SI 2010/1

Use of appropriate Oil Pressure Sensors

**Applies to all Pipistrel aircraft equipped with the
Rotax 912 engine series.**

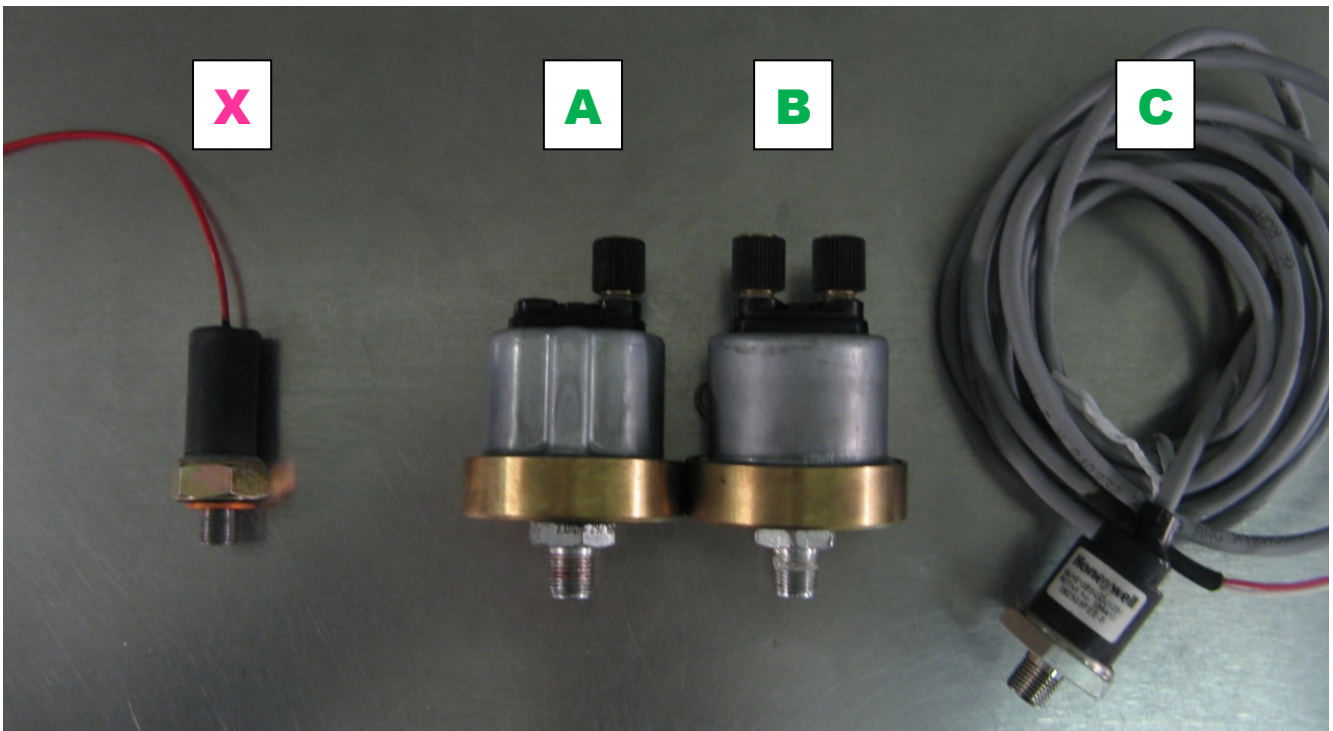
NOTE: the ONLY reliable way of determining whether your sensor needs replacement is by visual check. The sensor marked with **X** must be replaced due to a possible development of an oil leak, as described and mandated by the Service bulletin SB10. It is recommended that all owners verify that they are not using such a sensor (oil pressure switch type) at the moment, as it may have been installed during the regular servicing of the Rotax 912 engine.

WARNING! The sensor marked with **X** must be replaced immediately.

It can be replaced by any of the **A**, **B** or **C** sensor types. Based on our experience each of the sensor types has its advantages and disadvantages, therefore we are providing the following information and recommendations:

If you are currently operating the aircraft with the sensor **X**, you need to replace it immediately as per the Service Bulletin SB10. You yourself can decide which of the sensors **A, B or C** you will use in the future. The purpose of this Service Information is to assist you with choosing the most appropriate sensor for your aircraft, based on our compatibility research and experience with reliability.
